Re: 16-20 Medford Street building permit B24-000161, Request for Enforcement

Under provisions of MGL c. 40A s. 7. herewith we are requesting ISD to withdraw the construction building permit B24-000161 for the 16-20 Medford Street (the Development/Property), issued on July 17, 2024, due to significant zoning violations described herein.

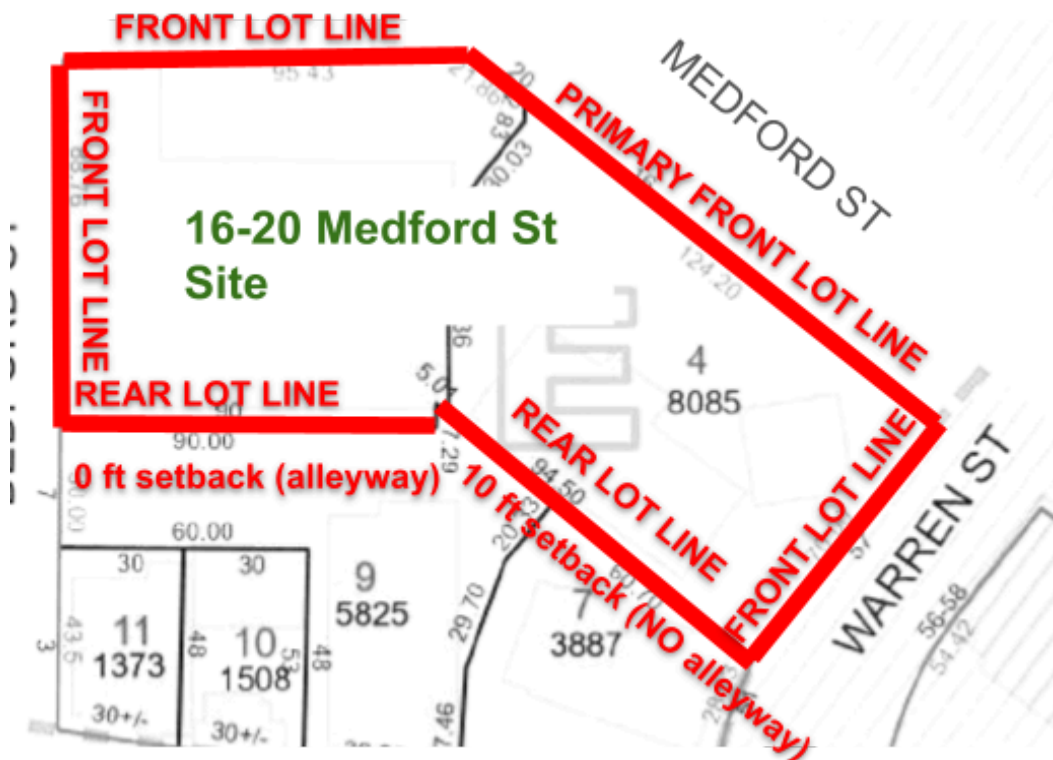
Issue #1. The Development violates Curb Setbacks on all four street frontages.

The “Curb Setback” of 12 ft, per SZO, extends vertically just as any other setback:

- *a. Building Setbacks*
 - *i. All principal and accessory buildings must be located at or behind any required minimum curb, front, side, or rear setback except as indicated in §2.4.3.d. Setback Encroachments.*

Please note that no building components (including Bay Windows) can encroach on the Curb Setback, per SZO. The corresponding setbacks for 16-20 Medford Street are depicted below:

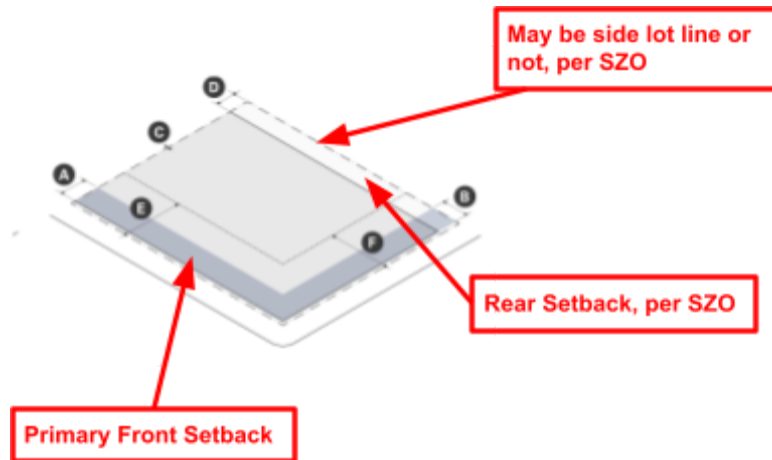
The proper lot line designation of the lot lines of the Property is presented on the following drawing:

The lot line that should have a 10ft setback is the right REAR LOT LINE (without the alley) on the figure above.

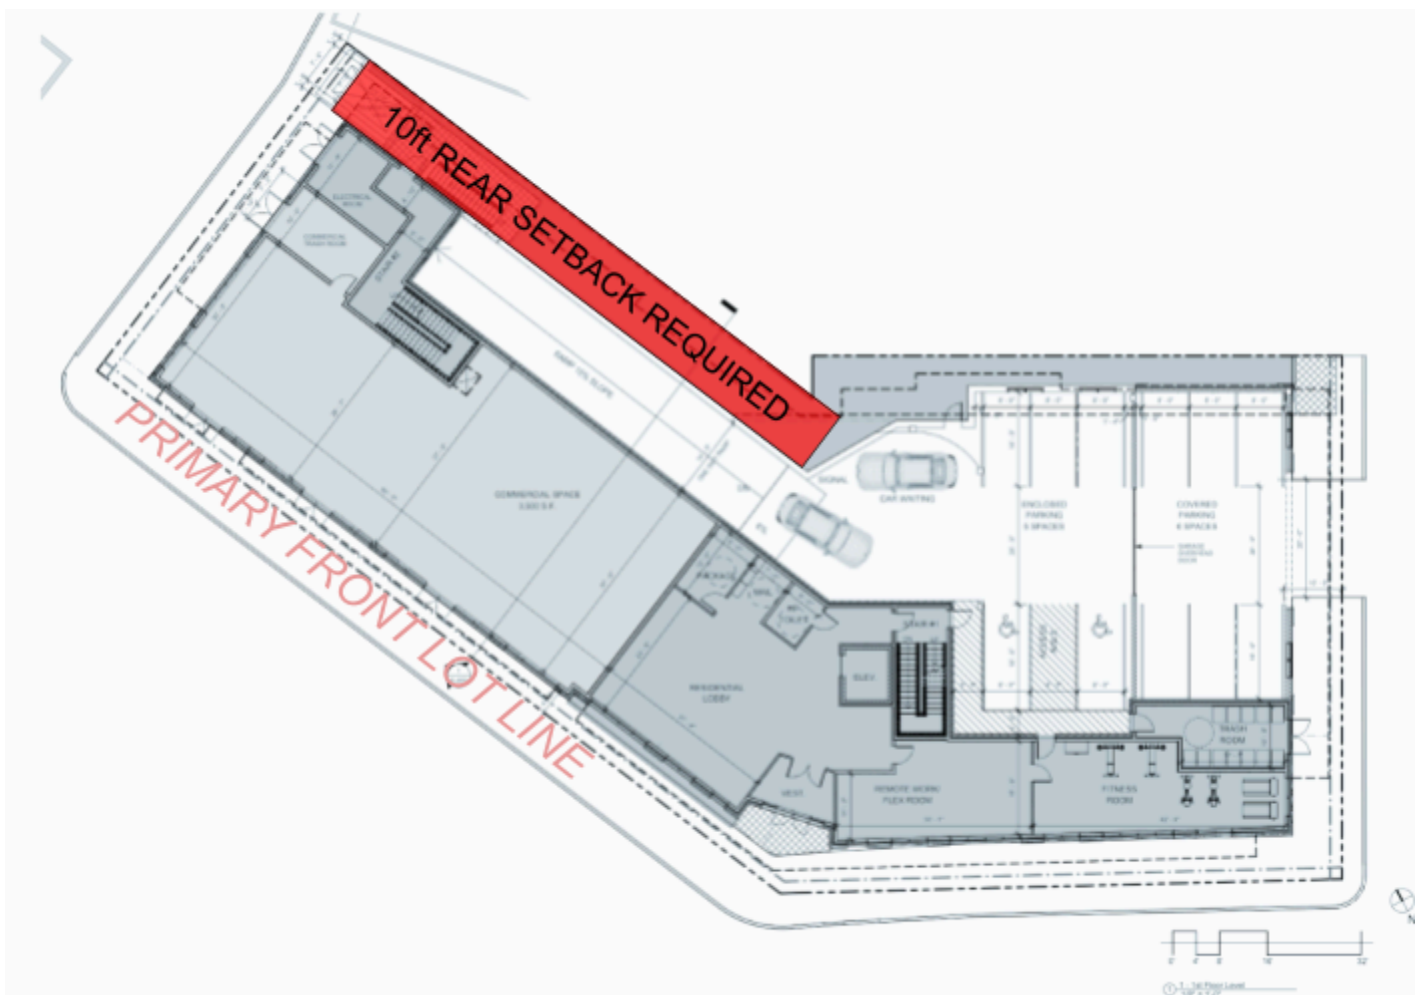
Regardless of the lot line designation, because it is located opposite of the Primary Front Lot Line (Medford St) of 16-20 Bedford Street, a REAR SETBACK is applicable to this lot line, by contextual drawing per SZO 4.2.8. b):

Here, the “Rear setback” (D) is depicted as the opposite of the “Primary front setback” (A). It is reasonable to assume that prescriptive drawing would mandate rear setback to be located along the opposite side of the Primary Front Lot Line. Please note that the line with Rear Setback may or may not be a Rear Lot Line, which, per SZO, depends on the adjacent lot’s arrangement. The

The required setback is depicted in RED on the figure above. As one can see, there are a lot of building components that encroach onto this setback. The Developers should reconfigure the building in order to not encroach onto this setback.
